Product Change Notification / GBNG-12RDMM715

CCB 5300 Final Notice: Qualification of MTAI as an additional final test site for MIC5060YML-TR, MIC37303YML-T5 and MIC37303YML-TR catalog part numbers (CPN) available in 8L VDFN (3x3x0.9mm) package.

Pre and Post Change Summary

Pre and Post Change Summary – Carrier Tape

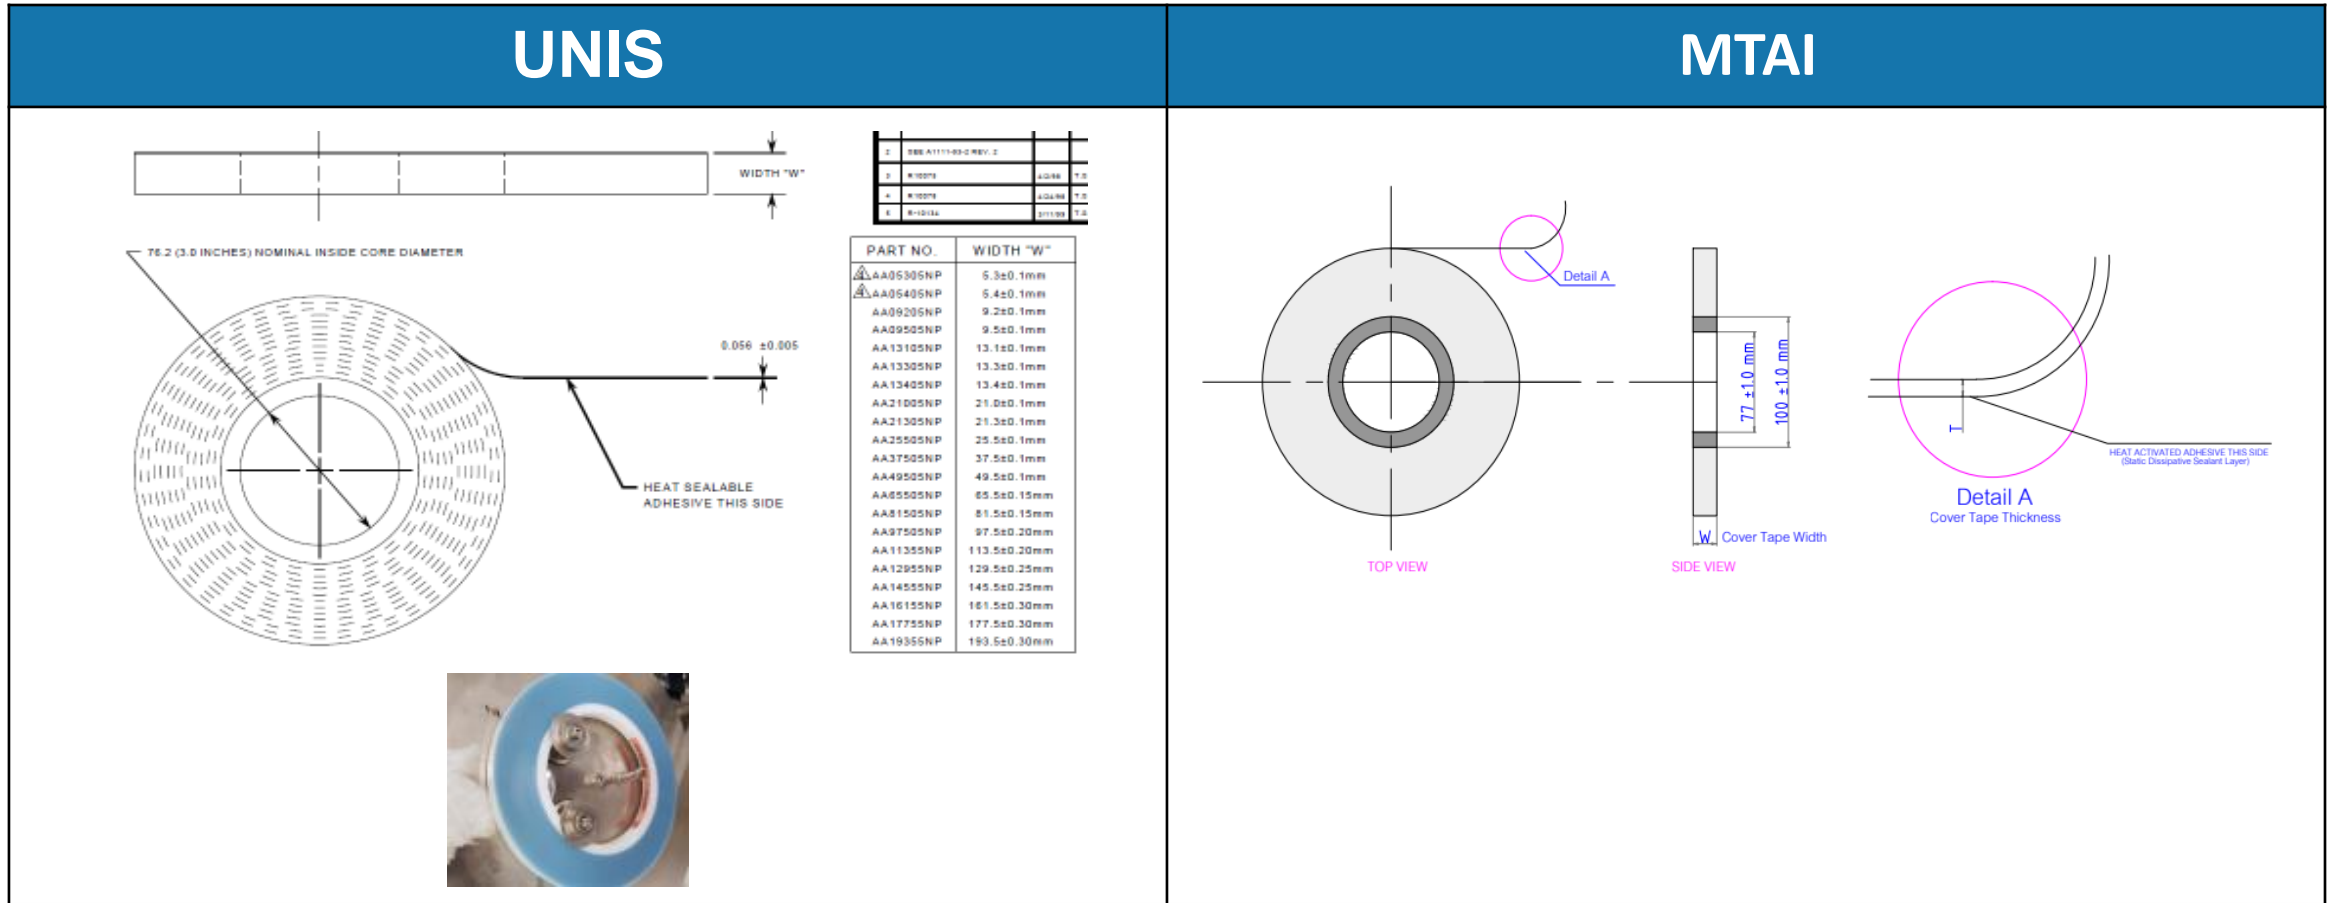
Supplier	W (mm.) ±0.3 or Specific	P (mm.) ±0.1 or Specific	A ₀ ±0.1 or Specific	B ₀ ±0.1 or Specific	K ₀ ±0.1 or Specific	Thickness ±0.05
1	12	8	3.30	3.30	1.00	0.30
2	12	8	3.30	3.30	1.10	0.30

Pre and Post Change Summary – Plastic Reel

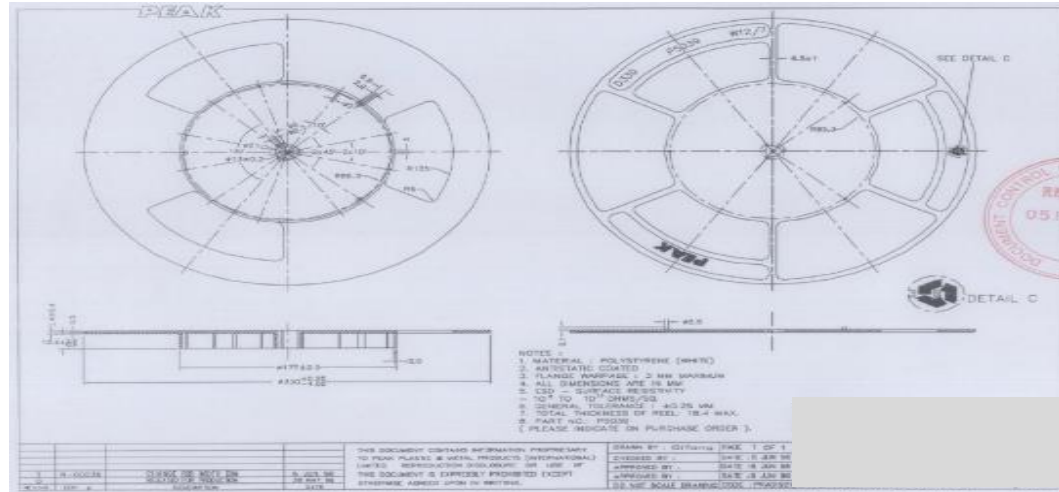
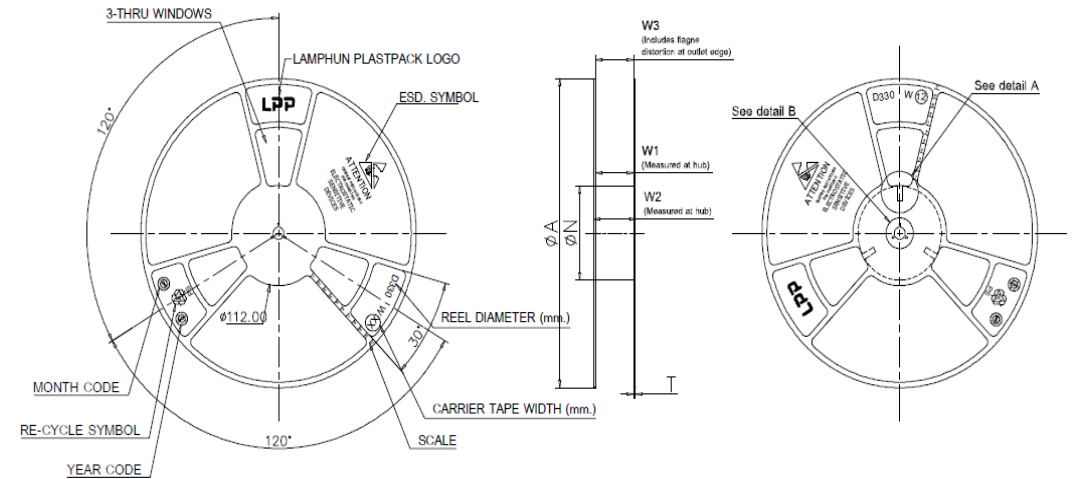
Plant	Package	Carrier Tape Width	Reel Diameter (mm.)	Reel Hub Size (mm)	Reel Width Max (mm.)	Color
UNIS	08LVDFN 3x3	12mm	330 +4.0/-0.25	177 ±2.0	18.40	White
MTAI	08LVDFN 3x3	12mm	330 ±2.0	100 ±2.0	18.40	Dark Blue
